Z-90 (2014) 0 COBB COUNTY PERMIT PLOT PLAN XXX-D-1001 MAGELLAN 510. Bouldair arceutice (CPC) ID HARCH S BASED for a Substitution of LLC. Failut D Pouchair Sametr of 58.31 A/M, accepting four Radio Application for the Control of Substitution (18", DHIO SPRICABIN 19, 2014, Standard BASED SAME CLASTON COMMANDER OF THE PROPERTY OF THE PROPE 10: 27 77 400 10: 27 77 400 10: 27 77 400 Und LON 13 & RE-15's princi, you union Com Court, Grown PLOT PLAN - 2 2014 THE DEVERSENCY XXX-D-1001 0

APPLICANT: Magellan Pipe	line Company, LP	PETITION NO.: Z-90
PRESENT ZONING: GC, H	I, R-20	PETITION FOR: HI
* * * * * * * * * * * * * * * * * * *	******	* * * * * * * * * * * * * * * * * * * *
ZONING COMMENTS:	Staff Member Responsibl	e: Terry Martin, MPA
	_	
Land Use Plan Recommendate	tion: Industrial Compatible	– Priority Industrial Area
Proposed Number of Building	gs: 3 Total Square l	Footage of Development: 4,740 sq. ft.
F.A.R.: <u>0.002</u> Square F	ootage/Acre: 81.43 sq. ft.	
Parking Spaces Required: 15	Parking Snace	s Provided: 16

Z-90 MAGELLAN PIPELINE COMPANY, LP

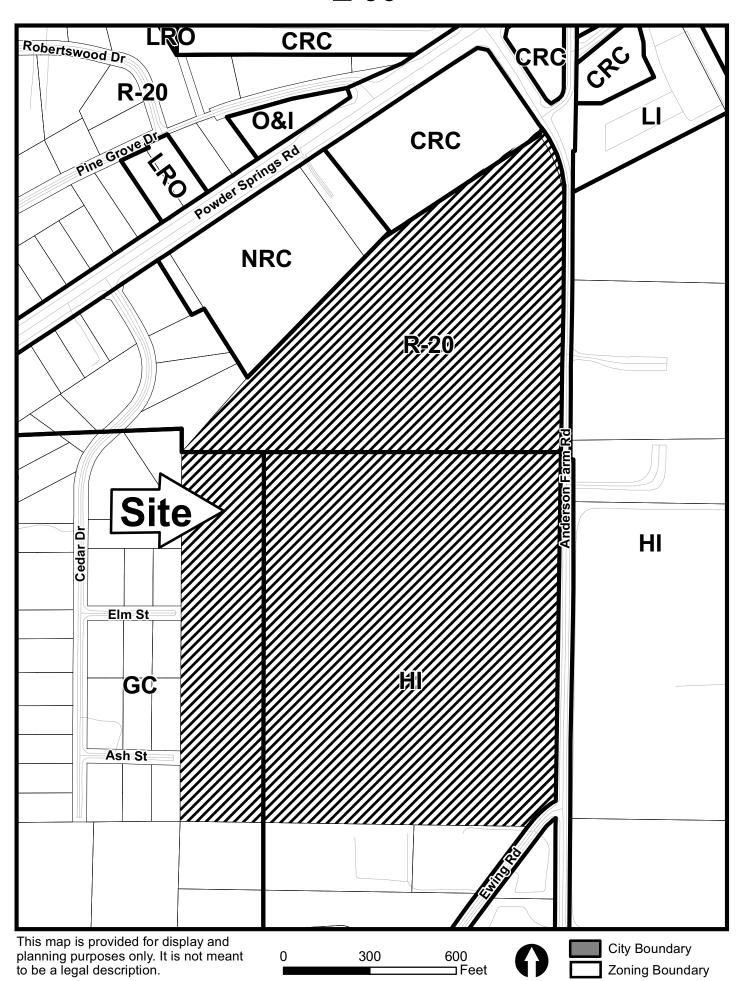
- 1. The entire site drains to the west through the adjacent Flint Hills Subdivision via two primary discharge points. The majority of the site will remain undisturbed with the proposed facility to be located near the southeast corner.
- 2. The proposed site plan may require a stream buffer variance, however it appears that the layout can be revised to eliminate the need for a variance. This issue can be addressed in Plan Review.
- 3. A Notice of Intent must be filed with the Georgia Environmental Protection Division for coverage under the NPDES General Permit to discharge stormwater associated with industrial activity. Any requirements associated with this permit must be addressed. A copy of the Stormwater Pollution Prevention Plan must be provided to the Stormwater Management Division.

Recommend applicant consider entering into a development agreement pursuant to O.C.G.A. 36-71-13 for dedication of the following system improvements to mitigate traffic concerns: a) donation of right-of-way on the west side of Anderson Farm Road, a minimum of 40' from the roadway centerline.

Recommend curb, gutter, and sidewalk along Anderson Farm Road frontage.

Recommend eliminating the proposed access closest to Ewing Road.

Recommend the proposed gate meet Cobb County Development Standards.

- Site plan received by the Zoning Division on October 2, 2014 with District Commissioner approving minor modifications;
- Maximum height of storage spheres up to 110 feet;
- Storage spheres to be painted muted colors and not used for signage or advertising purposes other than identification or other markings required by federal, state, or local regulations;
- Allowance of 24 hour operation and staffing of site;
- Spill containment plan, noise and air pollution abatement plans, and fire prevention, evacuation, and safety plan to be approved by staff;
- Fire Department comments and recommendations;
